Board of County Commissioners Summary Report

Case name: **PM22-006**
Arcadia Creek

RE: Arcadia Creek – Variance Requests to the Private Access

Re: Revised Variance Request Arcadia Creek
Technical Review Committee

DETENTION VARIANCE EXHIBIT

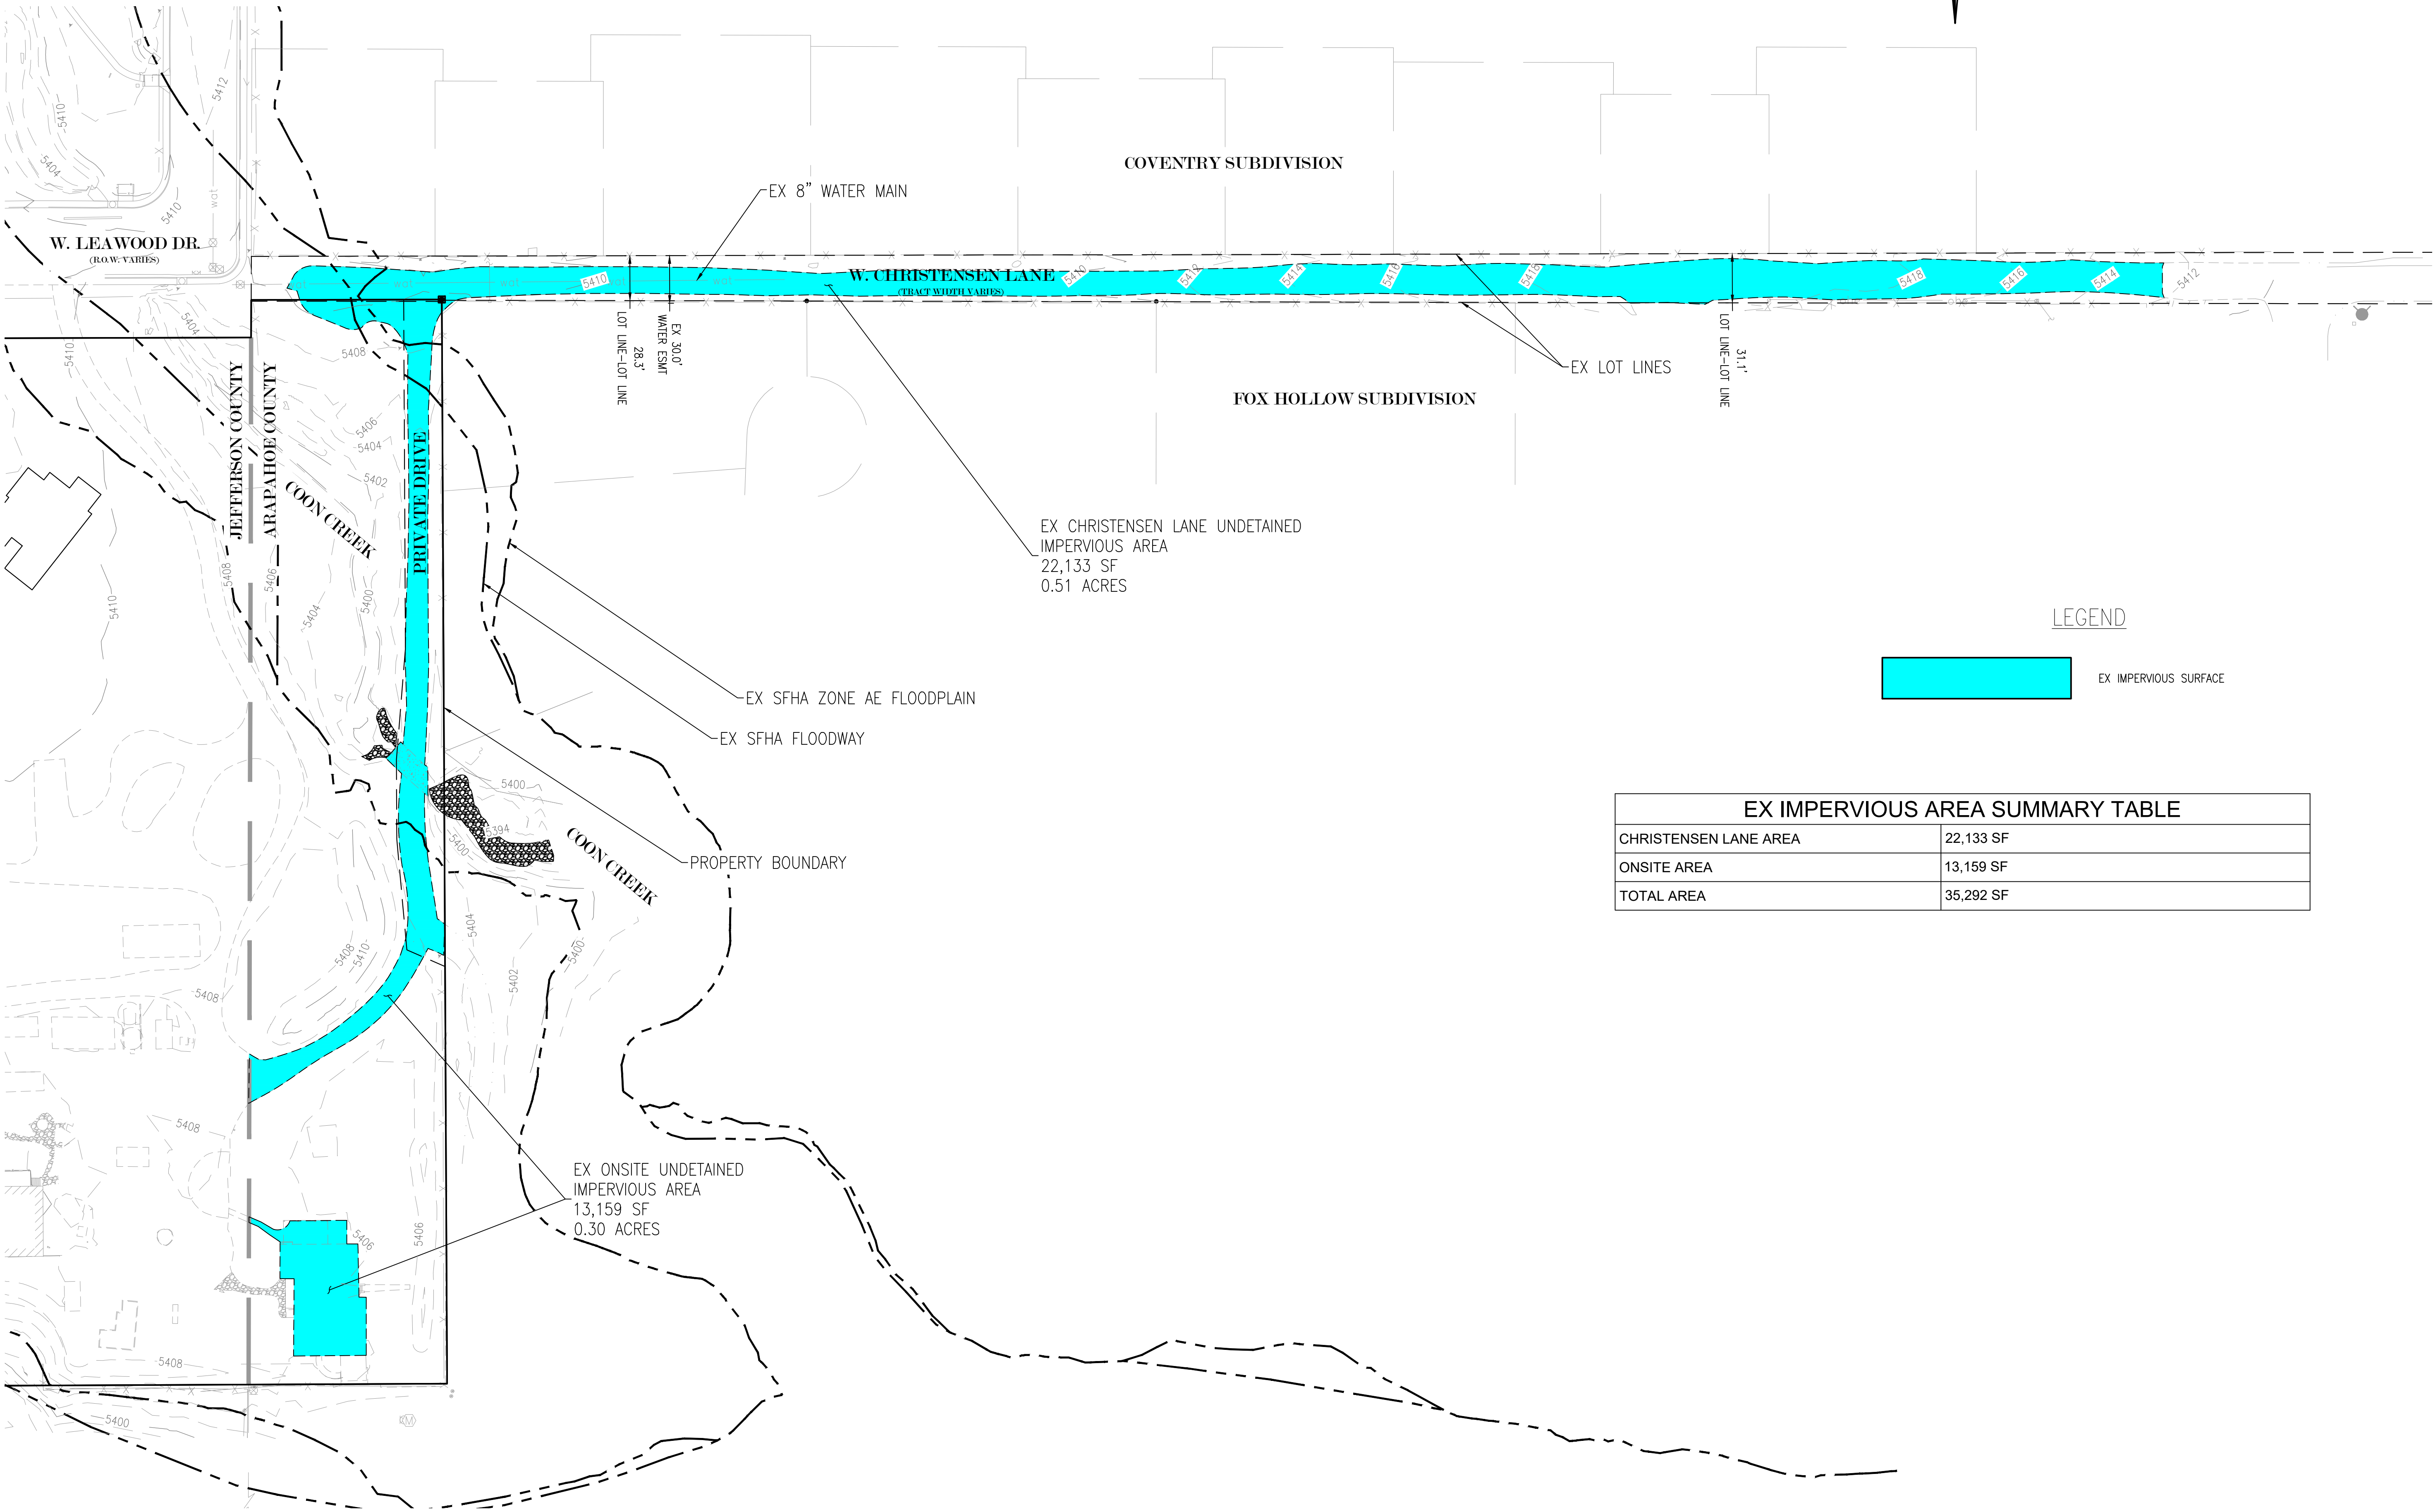
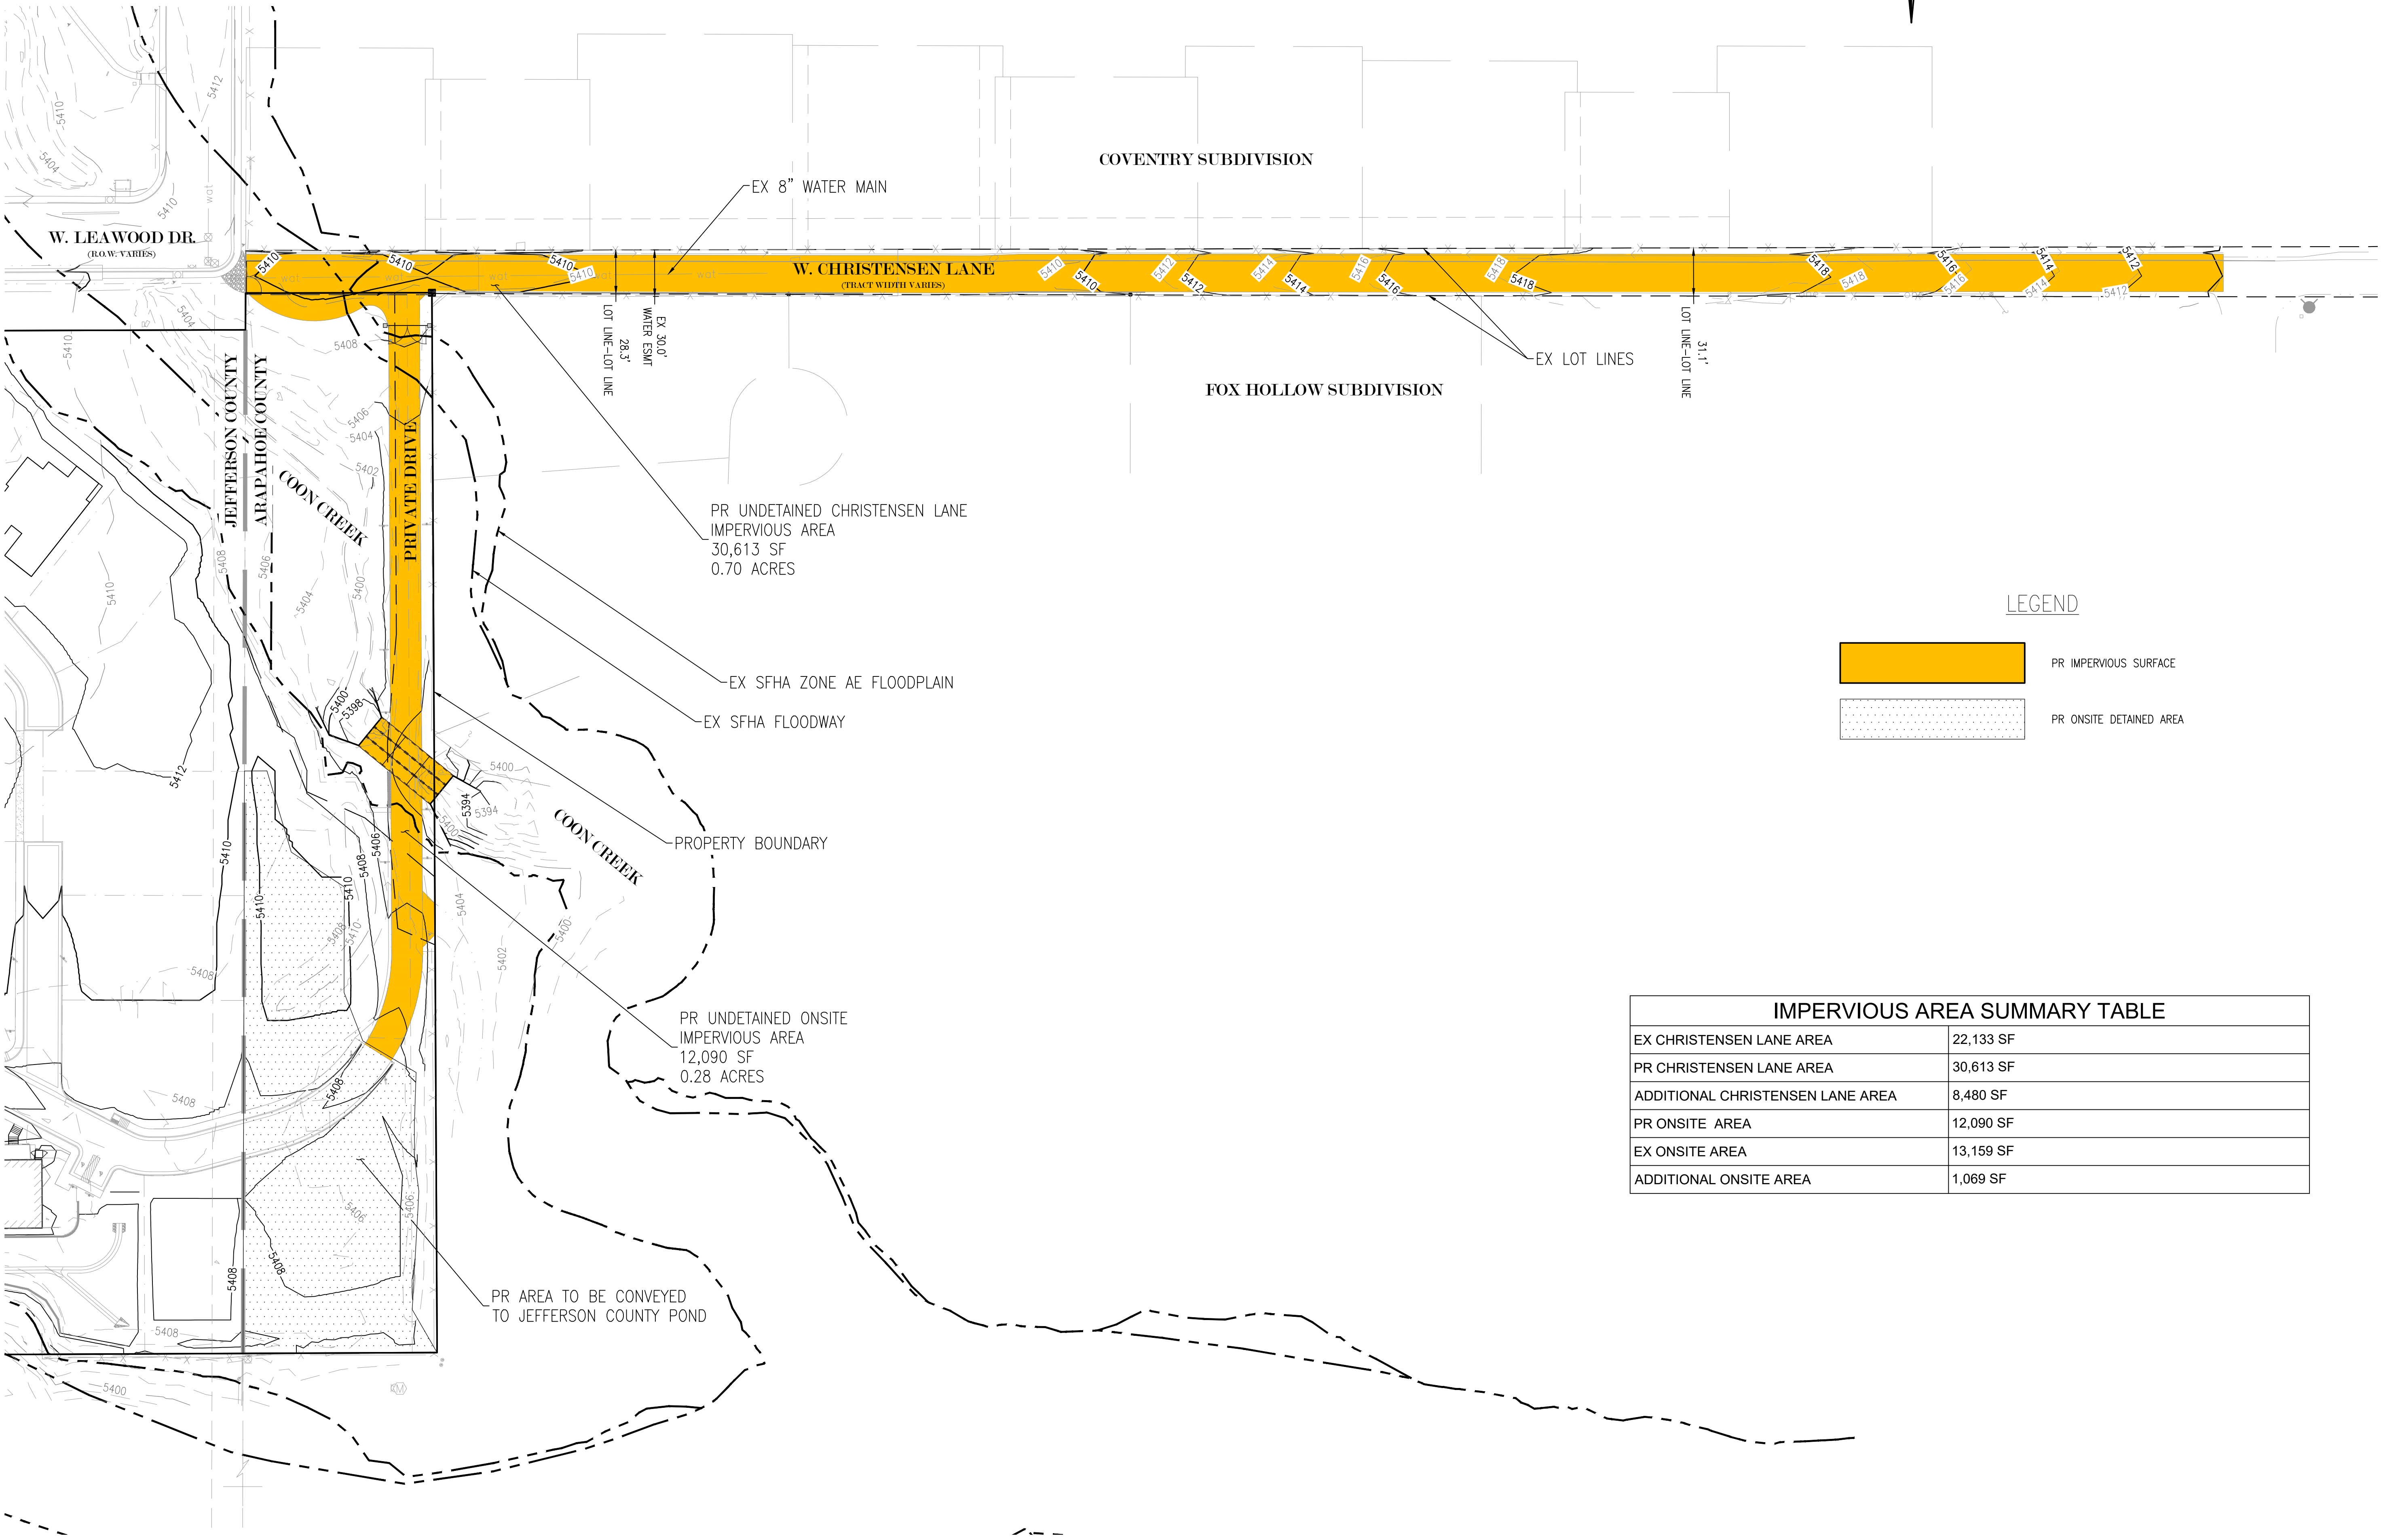
1. Existing and proposed flow rates and change in flow rates.

In the existing condition, the un-detained 100-year runoff from both Jefferson and Arapahoe Counties into Coon Creek is 9.08 CFS.

In the proposed condition, the un-detained 100-year runoff from both Jefferson and Arapahoe Counties to Coon Creek is 7.66 CFS.

A reduction of runoff to Coon Creek is approximately 1.42 CFS. This reduction is due to the fact we are detaining a portion of the basin that in the historic condition drains to Coon Creek. The two detention ponds in Jefferson County detain this flow and release into Dutch Creek. The Jefferson County ponds are designed to release below historic rates into Dutch Creek. The result of this development is a reduction in runoff to both tributaries.

- Existing and proposed flow rates and change in flow rates.
- Discuss how the un-detained flows will impact Coon Creek and Dutch Creek.
- Discuss how this flow impacts the peak within Coon Creek.
- How much detention volume would be required to detain the flows.
- Was any offset provided with the ponds in Jefferson County for the flows that go to Coon Creek? For example, did any flows that went to Coon Creek get transferred to Dutch Creek and included in the pond volumes.
